ARCHITECTURAL REVIEW COMMITTEE MEMORANDUM

SUBJECT: A REQUEST BY JR HAVENDALE, LLC, OWNER, FOR A MINOR ARCHITECTURAL APPLICATION TO MODIFY THE STOREFRONT OF AN EXISTING BUILDING FACADE FOR A NEW RESTAURANT, CHURRASCO BRAZILIAN STEAKHOUSE, ALONG A MAJOR THOROUGHFARE LOCATED AT 450 SOUTH PALM CANYON DRIVE, ZONE CBD (CASE 3.1294 MAA) (AR)

EXTERIOR ELEVATIONS

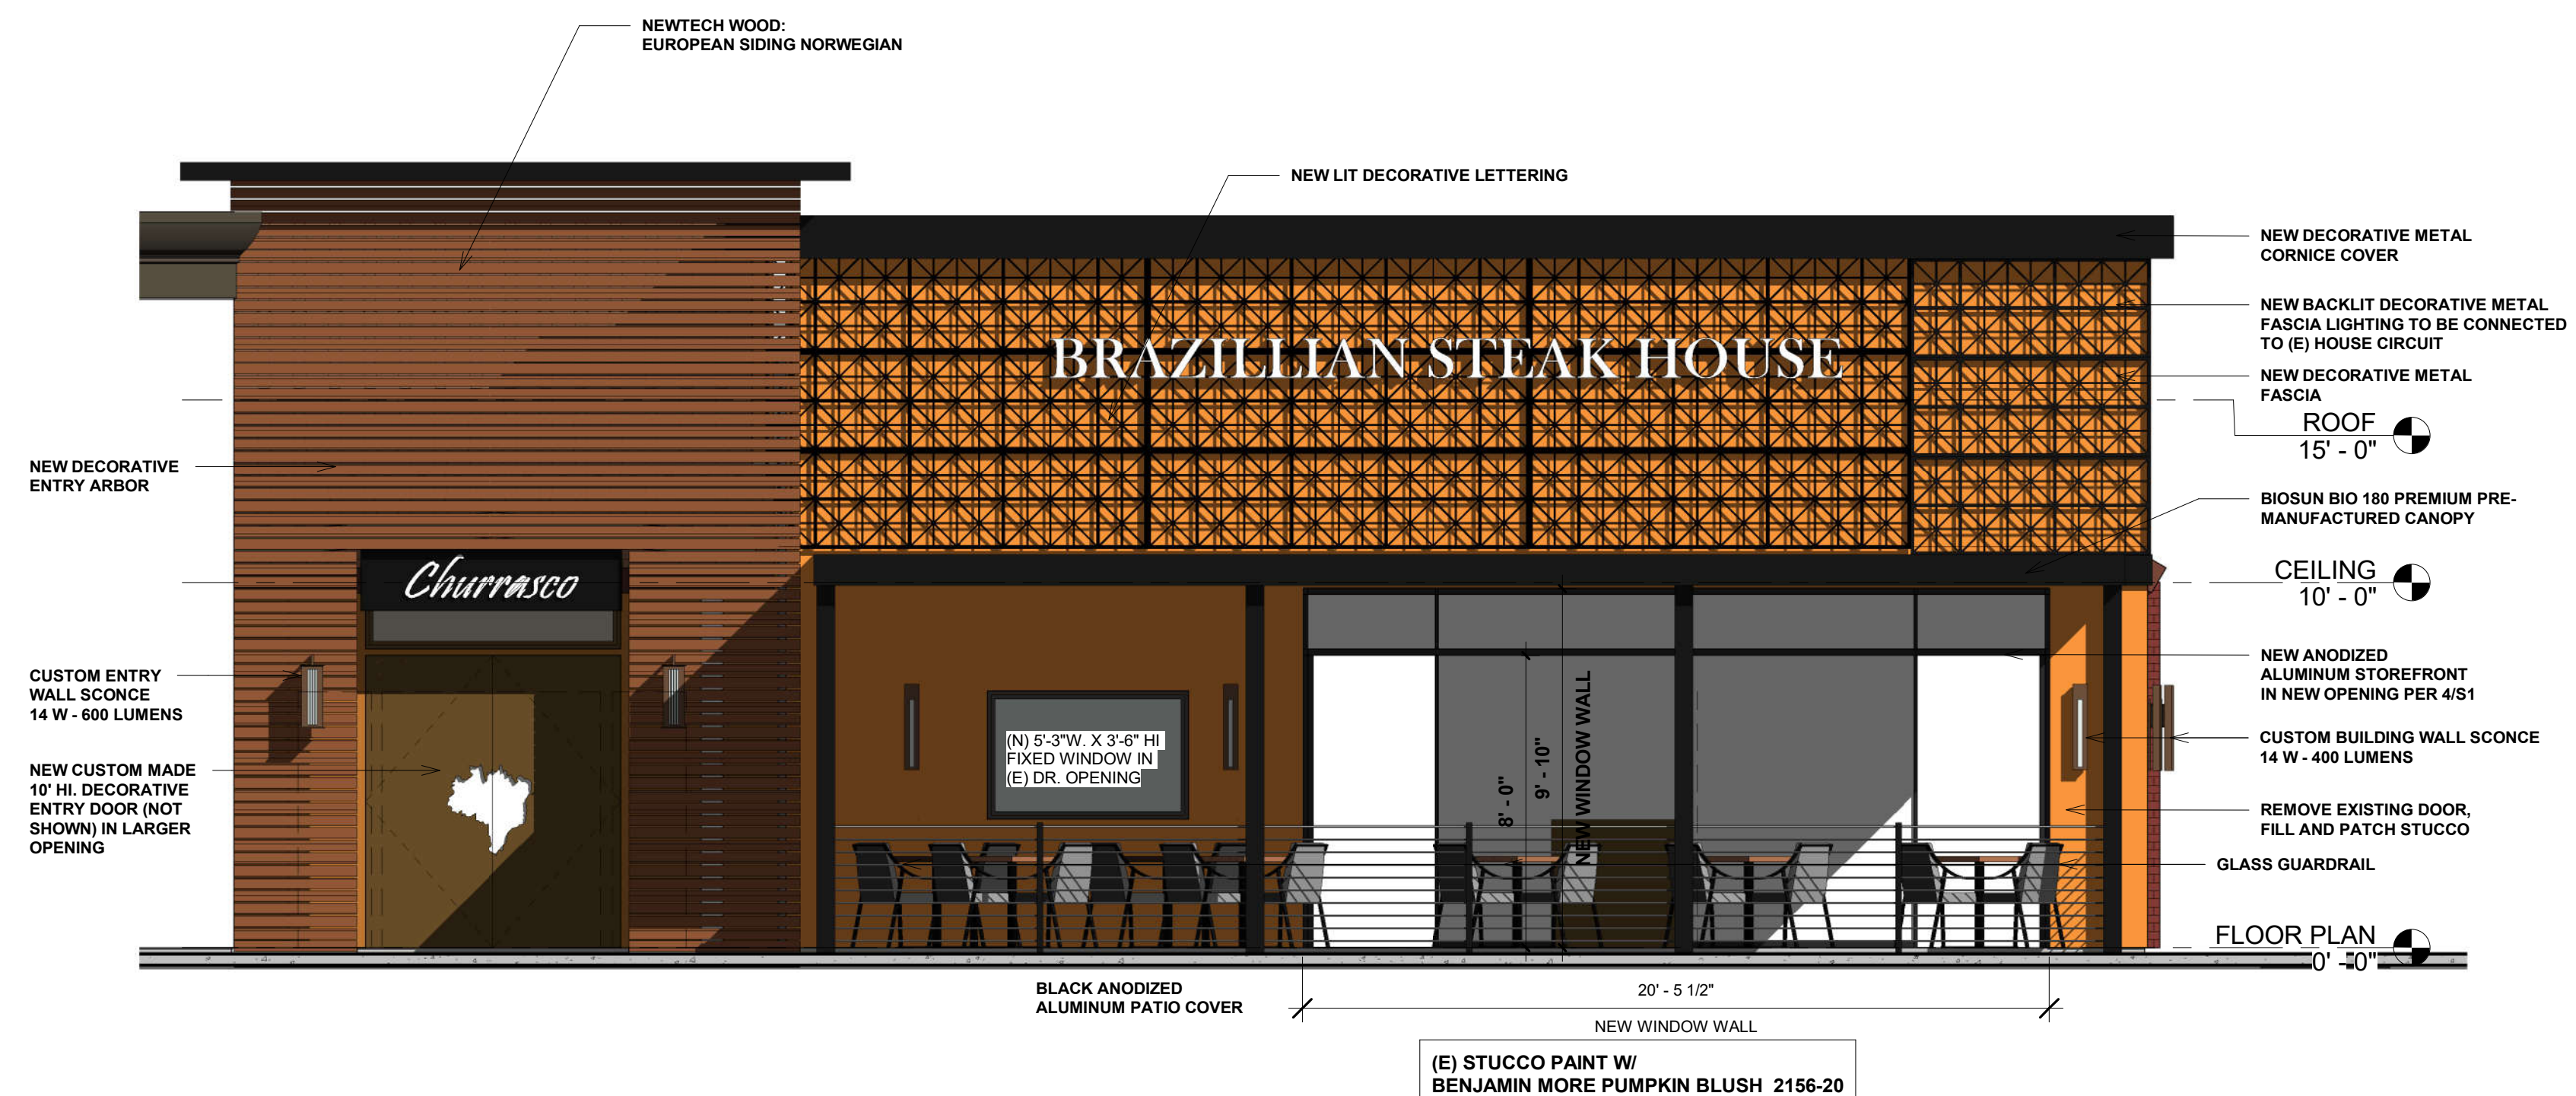
3.	<p><i>The façade elements and fenestration are composed in a harmonious manner;</i></p> <p>Currently, the storefront has several glass fixed window panels in a grid pattern, facing South Palm Canyon Drive. These will be replaced with black trim, fixed floor to ceiling window, and a new custom made 10' high, decorative entry door. The fenestration will be composed in a harmonious manner.</p>	Y

6.	<i>Shading devices and sun control elements, excluding landscape materials, are provided to address environmental conditions and solar orientation;</i> The storefront has an existing permanent shade element, which will be replaced with a more modern canopy. The canopy will provide adequate shade for the patrons of the restaurant and the outdoor patio area.	Y

7 ENTRY ARBOR FRONT - WEST STREET SIDE
 1/4" = 1'-0"

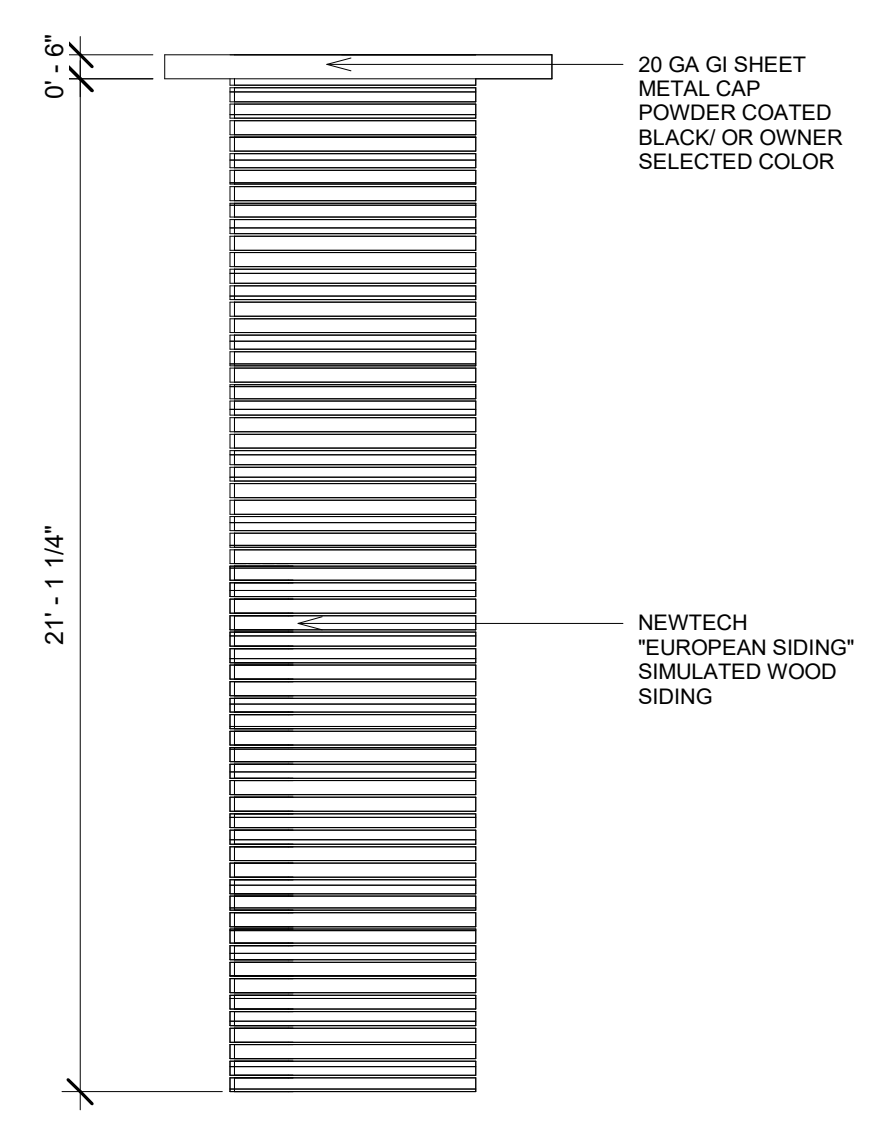
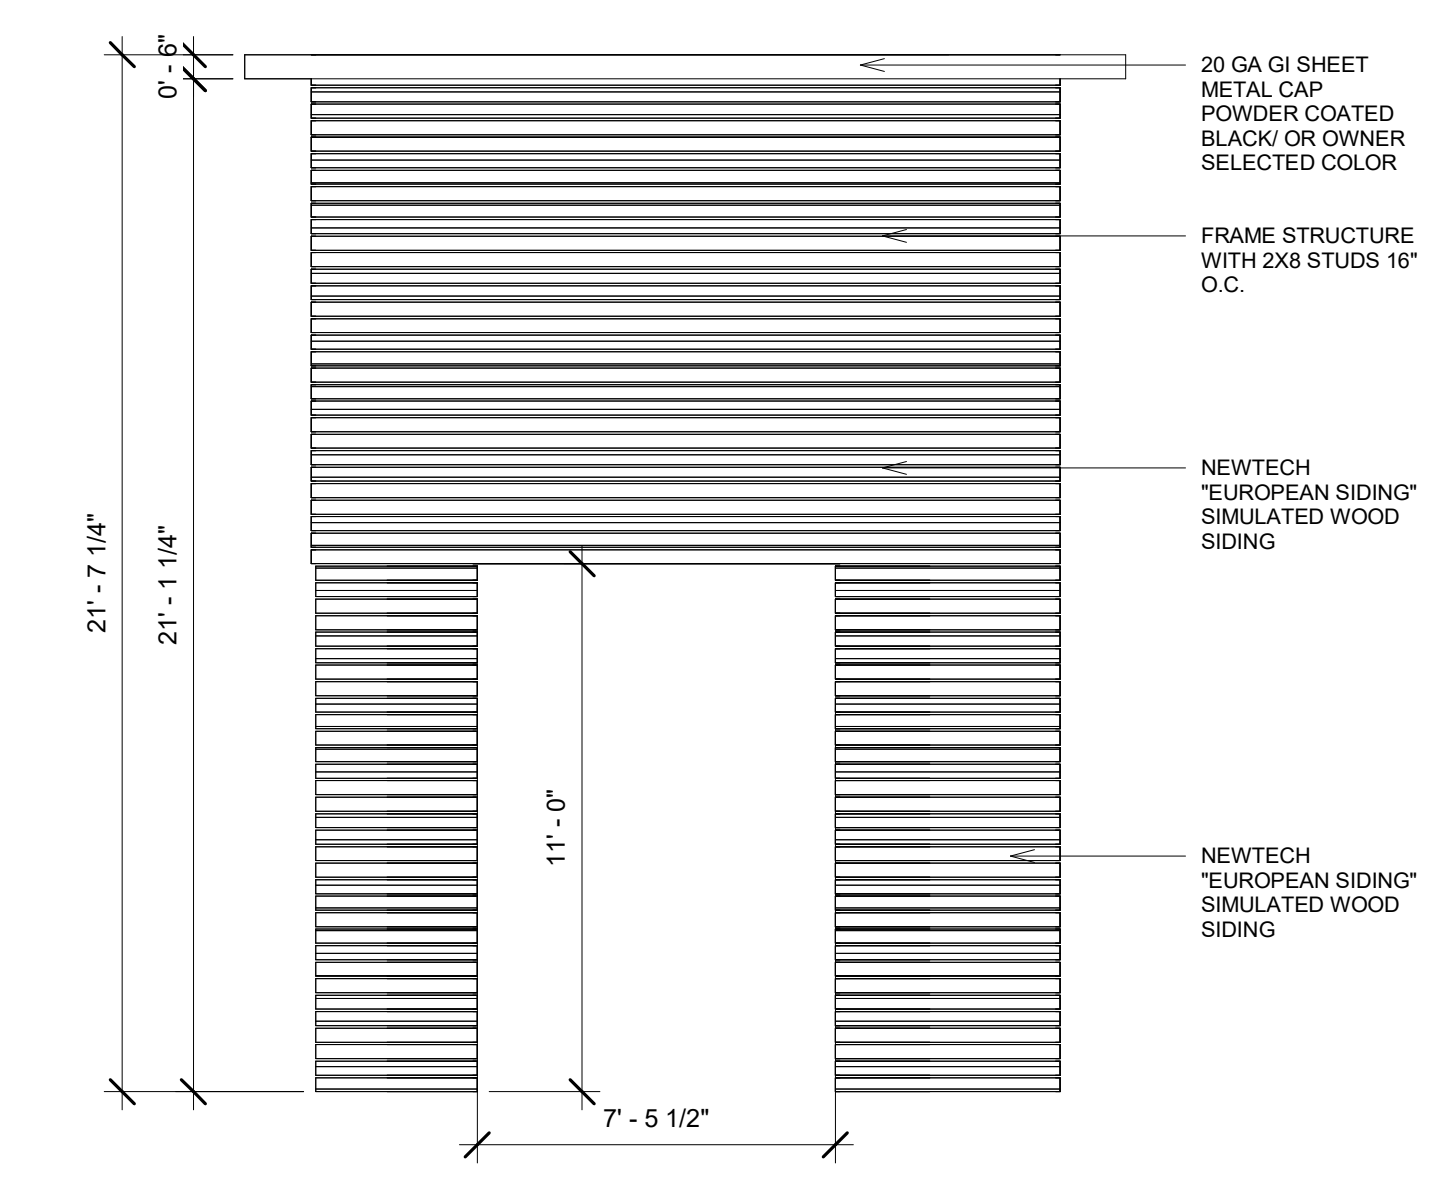
5.	<i>The proposed color scheme is appropriate to the desert environment and consistent with the site context;</i> The applicant is proposing to utilize black frames for the windows, fascia, canopy, a burnt orange for the stucco, and wood siding for the entry arbor. The color scheme is appropriate to the desert environment and consistent with the context of the site.	Y

ENTRY ARBOR WALL
SCONCE

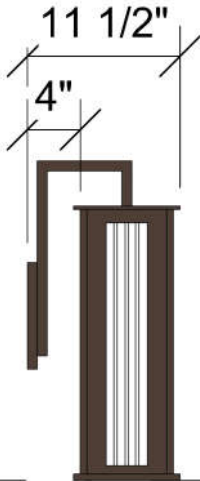
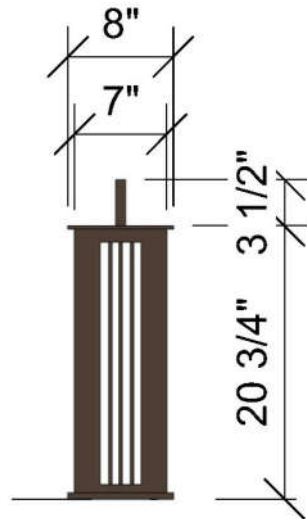
10.	<i>The proposed lighting plan is consistent with the requirements of PSZC Section 93.21.00, and the proposed lighting will not materially impact adjacent properties;</i> The applicant is proposing custom LED wall sconces (600 Lumens each), which will be a dark bronze color. Additional custom LED wall sconces (400 Lumens each) will be placed within the outdoor patio area and on a portion of the south elevation. The proposed lighting will not materially impact adjacent properties.	Y
